Access Compliance Report

Public Rights-of-Way

Intersection ID: 16008	Main Street: SEDGEFIELD_RD	Cross Street: WRISTON_PL	Location: NE
ADA ID: 845255C64A30	Ramp Type: Directional1	Initial Pass/Fail: Fail	Overall Compliance: No
		Severity Score: 12.5

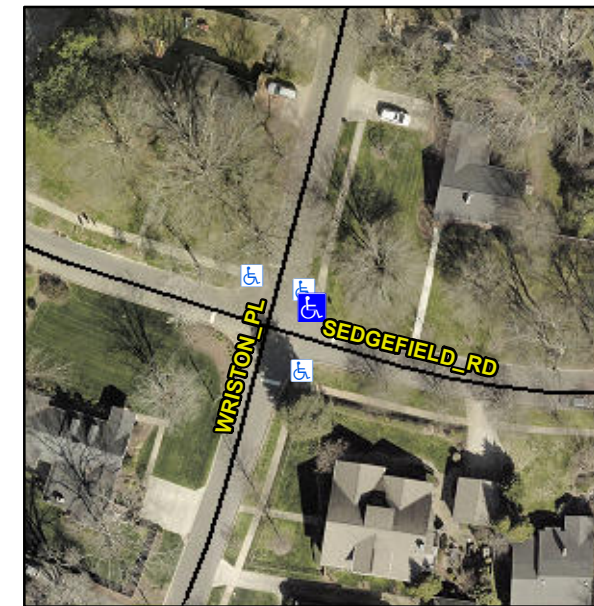
R304.2.2

Compliance	Description	Data	Compliance	Description	Data
N/A	Ramp Length (in)	76.0	N/A	Grade Break?	N/A
Yes	Ramp Width (in)	49.0	N/A	Grade Break Slope (%)	0.0
No	Ramp Slope (%)	10.7	N/A	Grade Break XSlope (%)	0.0
Yes	Ramp XSlope (%)	1.0			
N/A	Flare Type LT	N/A	N/A	Flare Type RT	N/A
N/A	Flare Slope LT (%)	N/A	N/A	Flare Slope RT (%)	0.0
N/A	Flare Traversable LT?	N/A	N/A	Flare Traversable RT?	N/A
N/A	Landing Length (in)	0.0	N/A	DWS Provided?	N/A
N/A	Landing Width (in)	0.0	N/A	DWS Contrast?	N/A
N/A	Landing Slope (%)	0.0	N/A	DWS Length (in)	N/A
N/A	Landing X Slope (%)	0.0	N/A	DWS Full Width?	N/A
N/A	Landing Curb? (Y/N)	N/A	N/A	DWS Offset LT (in)	N/A
N/A	Shared Landing?	N/A	N/A	DWS Offset RT (in)	N/A
N/A	Gutter Ponding?	0.0	N/A	Gutter Slope (%)	N/A
N/A	Gutter Lip Ht (in)	0.0	N/A	Gutter X Slope (%)	N/A
N/A	Painted X Walk1?	No		Road Slope (%)	0.5
	X Walk 1 Direction	To S		Road X Slope (%)	0.7
	X Walk 1 Width (in)	N/A		Clear Space?	N/A

Remove & Replace Entire Ramp.
